MVEIRB File Number: EA1011-001
Paul Mercredi
Environmental Assessment Officer
Mackenzie Valley Environmental Impact Review Board
P.O. Box 938
Yellowknife, NT X1A 2N7

**Re: Avalon Rare Earth Elements Incorporated Environmental Assessment
Information Requests**

Aboriginal Affairs and Northern Development Canada (AANDC) provides the following information requests (IRs) for the Avalon Rare Earth Elements Incorporated Environmental Assessment. AANDC believes that this information is necessary in assessing the potential impacts of the Thor Lake project.

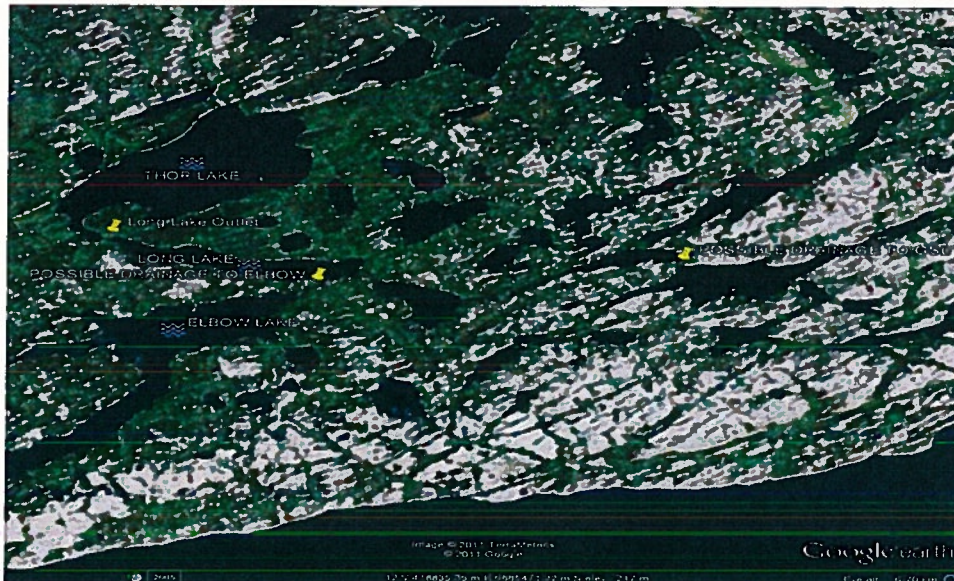
In the NWT, the major source of water is precipitation. To estimate flows and to adequately manage water, accurate input values of all environmental variables to the water balance equation must be available. The water balance simulations presented in the DAR calculate the water supply into Thor Lake on a monthly timescale, based primarily on i) estimated precipitation inputs from long-term climate data (from snowmelt release or rainfall); ii) the upstream contributing areas (including the proposed TMF area, Drizzle and Murky watersheds- 38%, Long Lake catchment- 45%, and remaining areas- 17%); and iii) spatially-invariant, monthly runoff coefficients. However, there are various sources of information in the DAR and consultant reports that suggest that the hydrology of the area requires improved understanding. In particular, the water supply from Long Lake (the largest sub-catchment) to Thor Lake appears uncertain for the following reasons:

Please summarize available field observations relating to observed drainage patterns, especially at locations where flat topography separating water sources would raise the potential for drainage courses to vary in direction. Specifically discuss the potential for water in Long Lake (and Long Lake catchment) to flow south towards Great Slave Lake (GSL) instead of through Thor Lake. Also discuss the implications of such a flow on the hydrological modeling conducted to date.

Thor Lake Rare Earth Metals Baseline Project
Environmental Baseline Report
Volume 1 – Hydrology
Interim Report

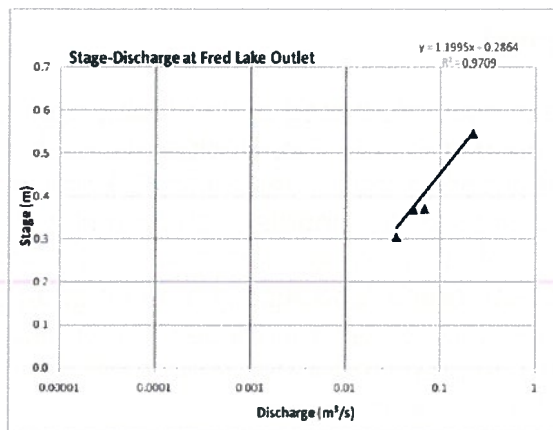
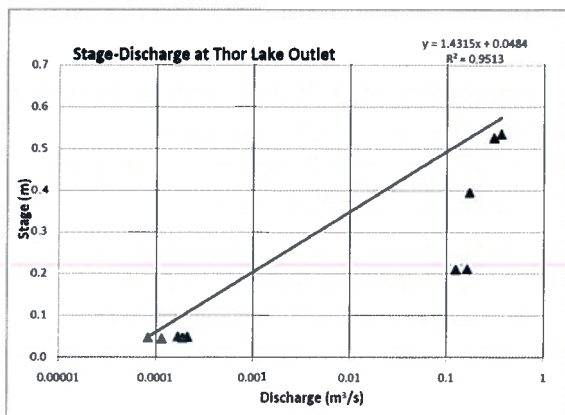
Related to this, in the rating curve developed from Stantec's measurements for Thor Lake Outlet (see below), please note that the rating curve developed for Thor Lake incorporates measurements obtained under very different stream conditions during 2008 (outlet blocked by debris; all flows less than $0.01 \text{ m}^3/\text{s}$) and 2009 (outlet not blocked from June; flows all above $0.1 \text{ m}^3/\text{s}$).

Please identify a set of physical processes that would combine to explain the relative differences observed in measured discharges from Thor (upstream) and Fred (downstream), for each year including 2008 ($F > T$), 2009 ($T > F$) and 2010 (both $F > T$ and $T > F$). For instance, if there were other potential outlets from Fred Lake than the one measured, especially during higher water levels, please provide any supporting information. If the candidate processes include physical impoundments (as noted for Thor Lake in 2008, but this may also be the case at Fred Lake), how would this be expected to affect the timing and quantity of Thor Lake outflow (stated as 1.725 million m^3/yr)? This could be addressed by re-estimating the Thor Lake outflows using separate rating curves developed from measurements obtained during blocked conditions (pre-June 2009) and unblocked conditions. If water supply does become 'impounded' at Thor Lake, what would the implications be on water quality?
